MINUTES
FLOOD CONTROL DISTRICT ADVISORY COMMITTEE/PUBLIC REVIEW
February 15, 2012

Technical Appeal and Variance Request for Properties Located at 10385 and 10395 South Nogales Highway, Sitting as the Flood Control District Advisory Committee

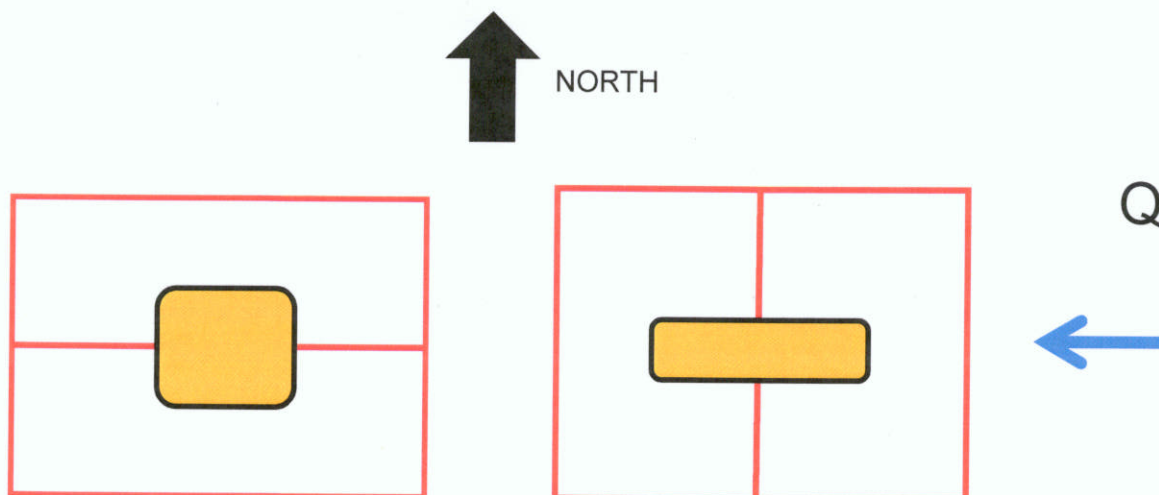
Regarding the aerial photo included as the 14th sheet in the information packet distributed to the committee, this aerial photo is in color, is a reduced in size copy of an original document at a stated scale of 1 inch = 100 feet, and shows parcel boundaries, the location of the proposed fill pad (yellow rectangle), the HEC-RAS cross sections, the 100-year floodplain limits from the HEC-RAS model, and areas with $dV^2 > 18$ and $Y > 3$ feet as identified from the HEC-RAS model. In this aerial photo, the two parcels in question are in the center of the sheet; the southern parcel is shown to contain the proposed fill pad (yellow rectangle), and the northern parcel is north of, and contiguous with, the southern parcel.

District staff pointed out that, in previous discussions between District staff and the engineer (Mr. Desai) for the parcel owner, it was agreed that the two parcels would be recombined and then split in a north-south direction (Exhibit B) instead of the east-west split (Exhibit A) shown in the aerial photo. The purpose of this change was to reduce the obstruction to flood flow due to placing a fill pad on both parcels. By splitting the combined parcel in a north-south direction, the fill pads could be aligned in a series configuration, which would reduce by half the width of obstruction of the fill pads to the flood flow.

District staff further pointed out that with this proposed re-splitting and reconfiguration of the fill pads, the encroachment criteria of the Floodplain and Erosion Hazard Management Ordinance was still exceeded, but by less. The owner's engineer responded to this condition by proposing to provide additional flow conveyance along the north side of the proposed fill pads. The additional conveyance was to be created by excavating an area between the north edge of the fill pad and the north property line of the northern parcel (under the re-split configuration). The conveyance area was to be 80 feet wide and 6 inches deep. This area was then to be placed in a dedicated private drainage easement.

Based on the information presented, a motion was made to uphold the Chief Engineer's decision to deny the FPUP applications. The motion was seconded.
